3106-05M 10314 Armory Ave  
Kensington Historic District

SUBJECT: Historic Area Work Permit Application #388267

#### *Removal of two walnut trees and installation of a screening fence.*

**HISTORIC PRESERVATION COMMISSION STAFF REPORT**

Plan for fence 10314 Armory Ave

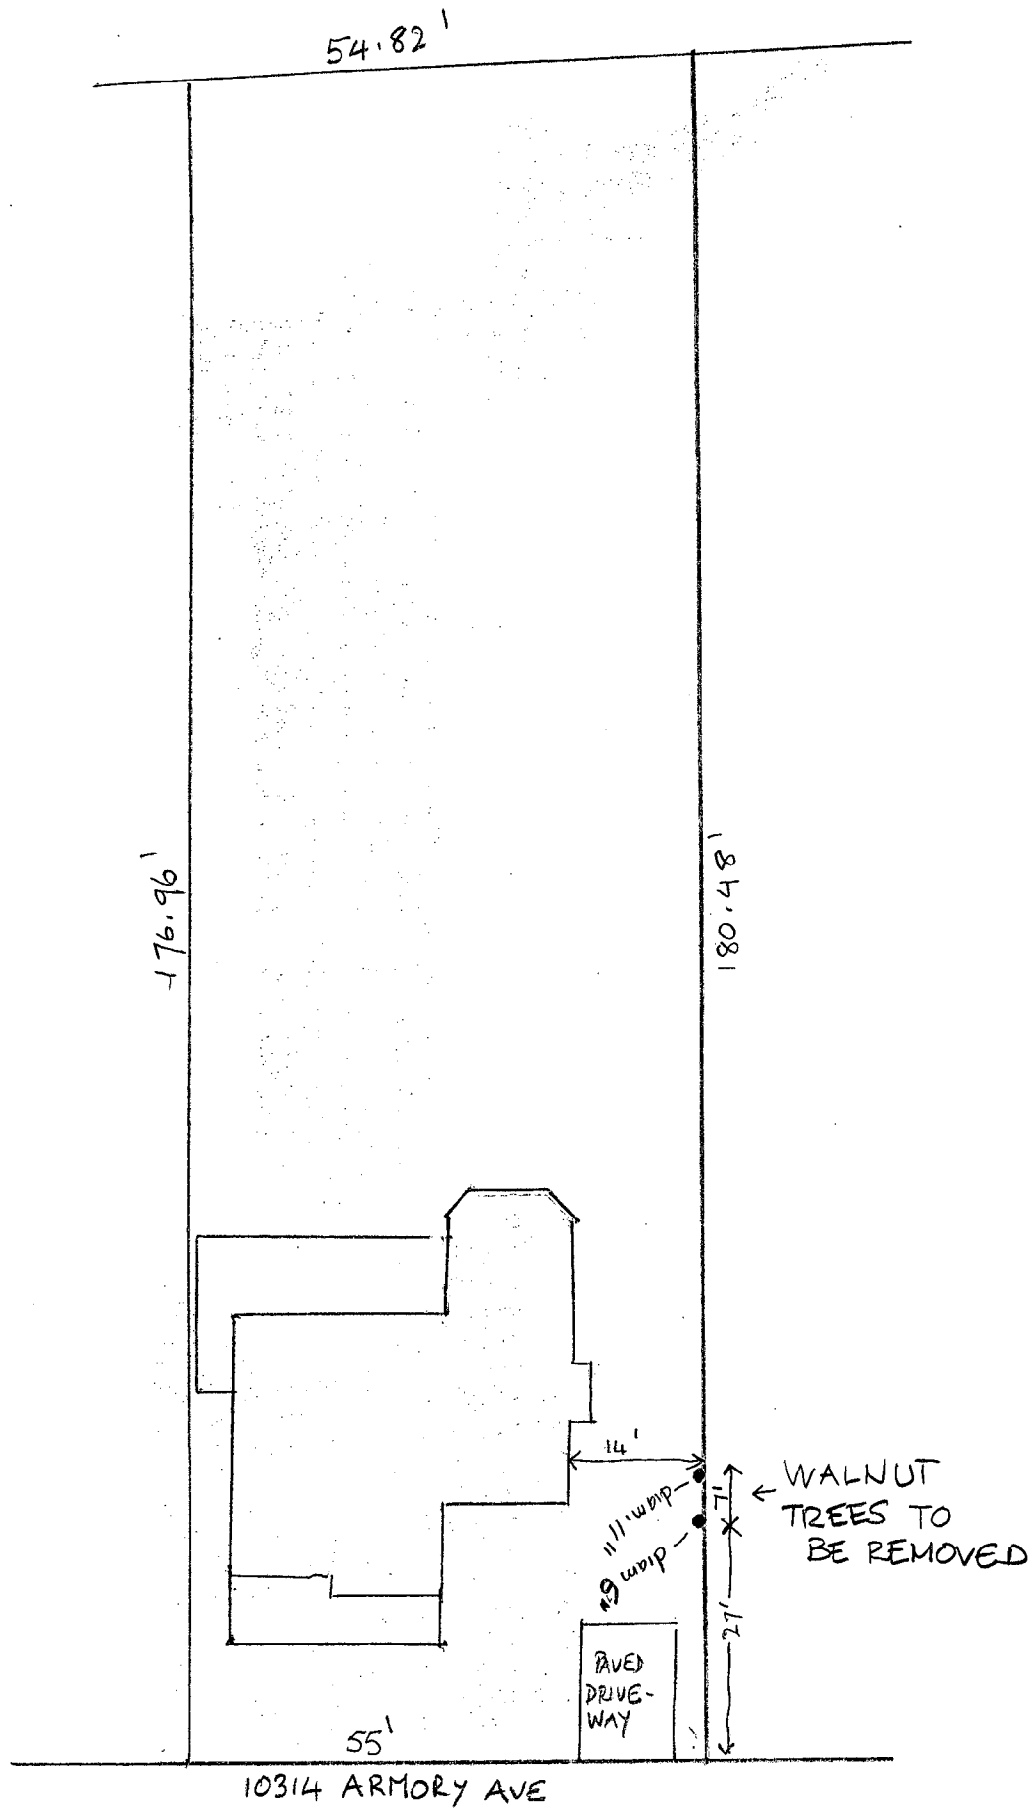
Total Fence length  
not to exceed  
112 feet.

This  
section is  
wood privacy  
fencing not  
to exceed  
6 1/2' in height.

The height  
changes of the  
rear plane of  
10316 Armory.

This section of wood  
picket fence  
to match height of  
existing picket fence on  
the property, not to  
exceed 4' in height.

1. For each tree to be removed, one tree from Montgomery County's native species list that is equal to or superior to the removed trees in terms of species quality, shade potential, and other characteristics (min. 3" caliper deciduous or 6' high evergreen) will be planted on the property.
2. The fencing will not be higher than 4' in the front or side yard. It will step up at the rear plane of the house on the adjacent property.

Plan for fence 10314 Armory Ave

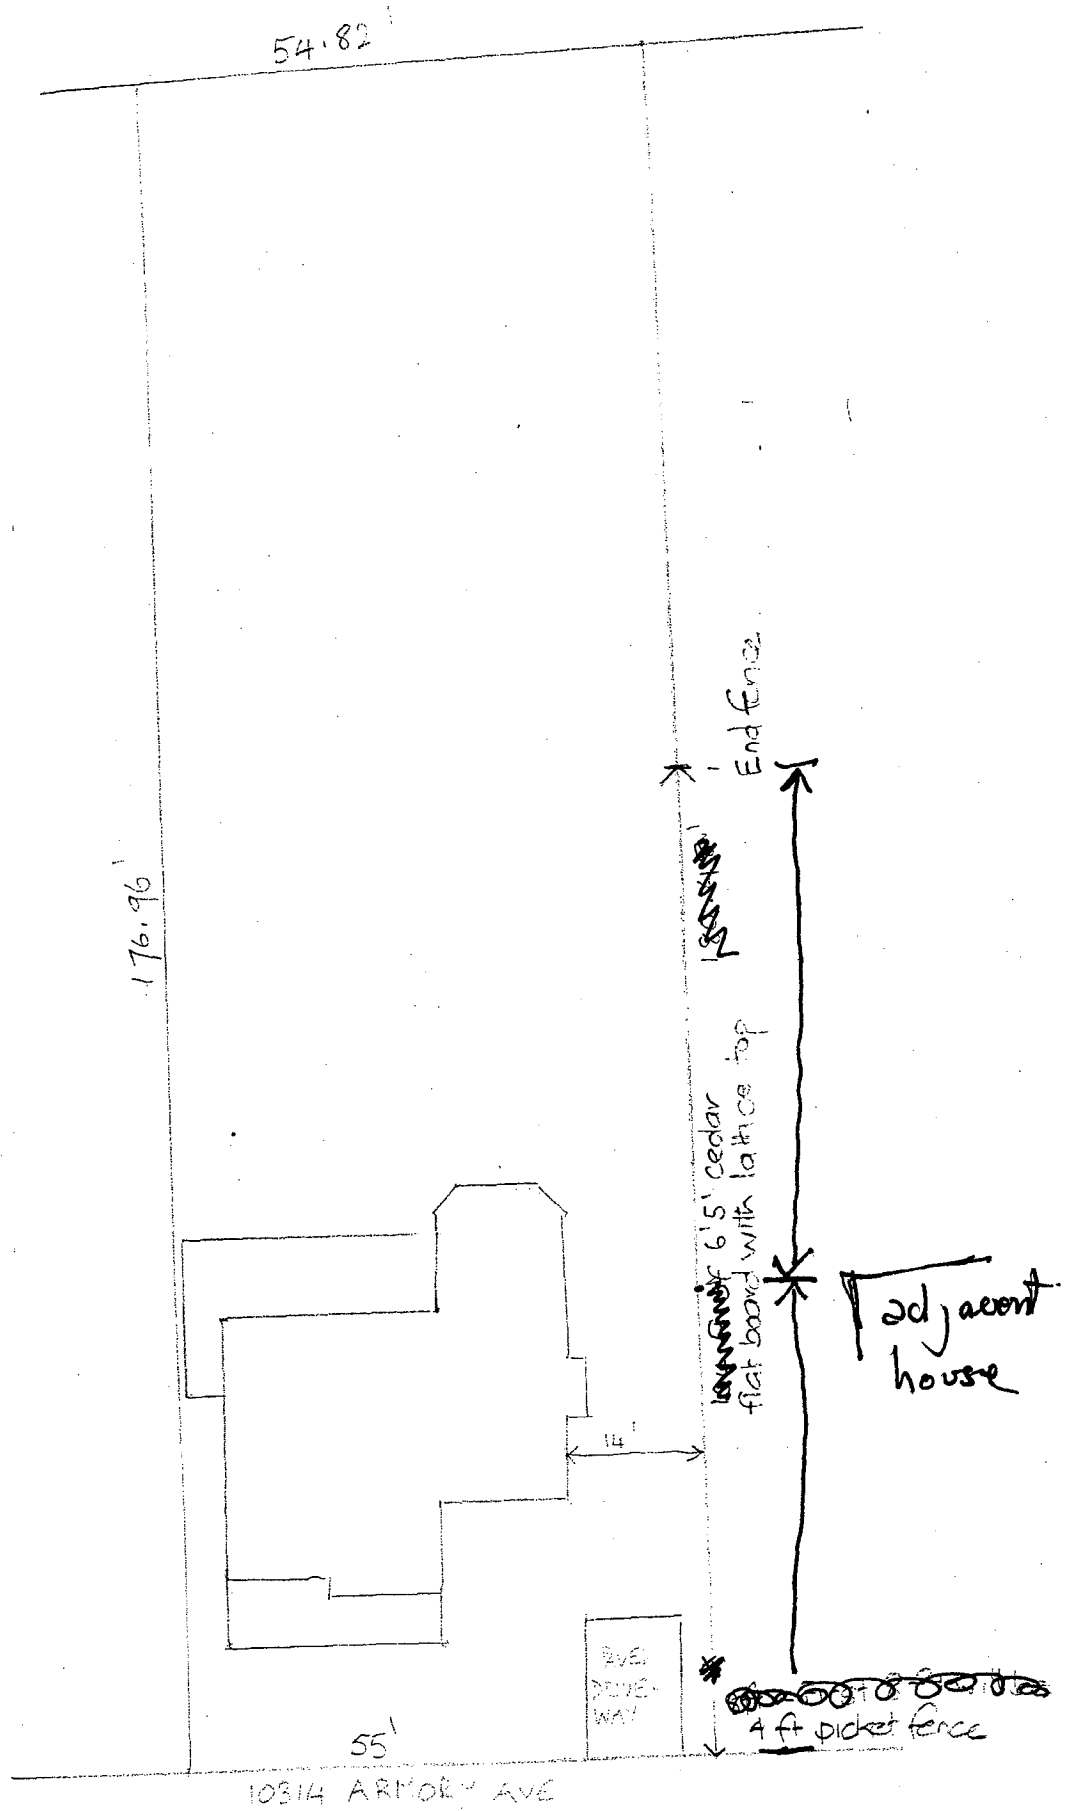
STAFF RECOMMENDATION

Begin Privacy Fence here

1. For each tree to be removed, one tree from Montgomery County’s native species list that is equal to or superior to the removed trees in terms of species quality, shade potential, and other characteristics (min. 3” caliper deciduous or 6’ high evergreen) will be planted on the property.
2. The fencing will not be higher than 4’ in the front or side yard. It will step up at the rear plane of the house on the adjacent property.
